# 1992 Corvette: Recall: Instrument Panel/Left Hand Lower Trim/Brake Pedal Interference

**Subject:** PRODUCT CAMPAIGN 92C10 - INSTRUMENT PANEL LEFT HAND LOWER TRIM PANEL/BRAKE PEDAL INTERFERENCE

**Model and Year:** 1992 CHEVROLET CORVETTE

**Bulletin Number:** 92C10 - (04/23/1992)

Figure 1

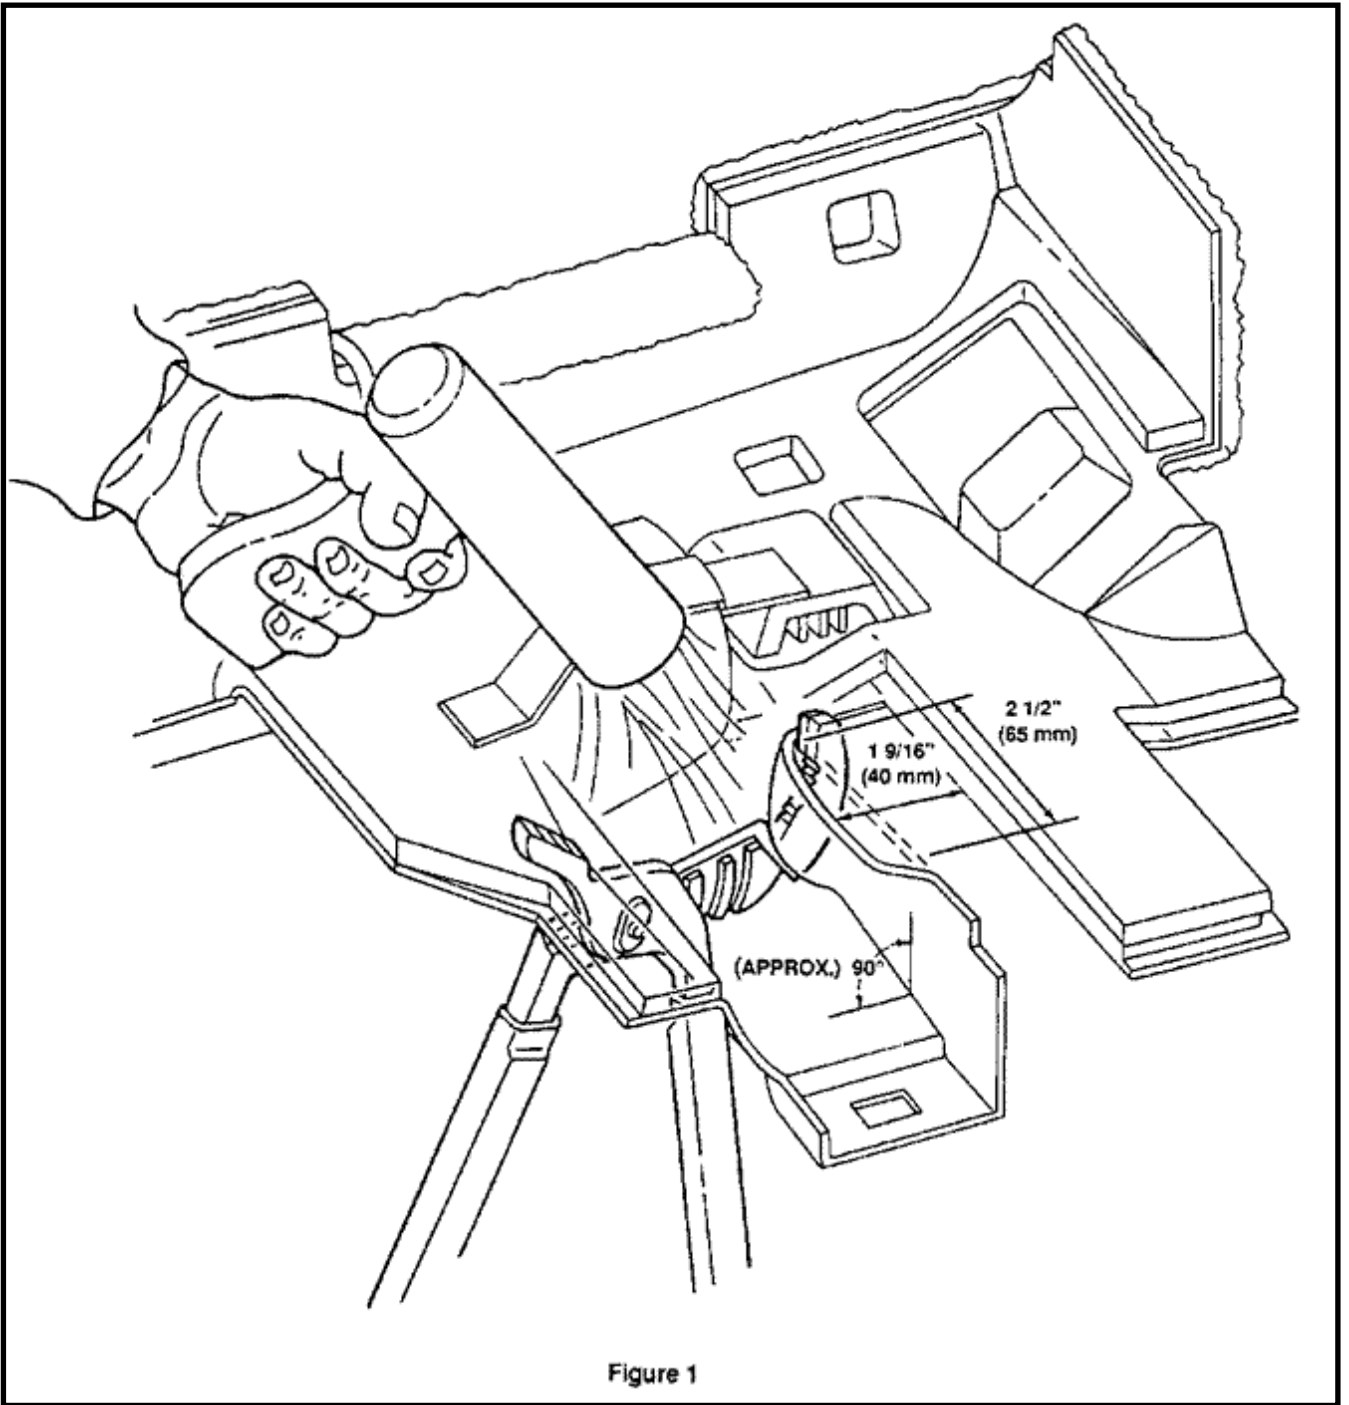
To prevent this condition from occurring, dealers are to inspect for proper clearance between the brake pedal arm and the instrument panel (I/P) left-hand lower trim panel. If clearance is not sufficient, the trim panel will be modified with a heat gun.

Attempt to pass an item approximately 2mm thick (such as a 2mm shim) between trim panel and brake pedal arm on both sides of pedal arm along entire length of pedal travel.

1. Remove I/P left-hand lower trim panel (per Preliminary Service Manual, Section 8C-33).
2. Lift away foam sound deadener from area shown in Figure 1 and tape out of way.
3. Using a heat gun, warm trim panel area shown in Figure 1. **USE CARE TO WARM COMPLETE AREA EVENLY.**
4. Using Channel Locks size 16 or larger, place near upper left-hand corner of I/P left-hand lower trim panel as shown in Figure 1. Quickly reform brake pedal opening to configuration and dimensions indicated in Figure 1. If necessary, Channel Locks may be moved downward during initial reforming and/or steps 3 and 4 may be repeated to obtain minimum clearance of 2mm between brake service pedal arm and I/P left- hand lower trim panel.

**Notice: To lessen Channel Lock imprint, place smooth shim stock or aluminum face cover between Channel Lock face and warmed surface of I/P left-hand lower trim panel.**

5. Reinstall I/P left-hand lower trim panel. Remeasure clearance between trim panel and brake pedal arm along entire length of pedal travel, using "INSPECTION" procedure on page 2.
6. Install Campaign Identification Label.
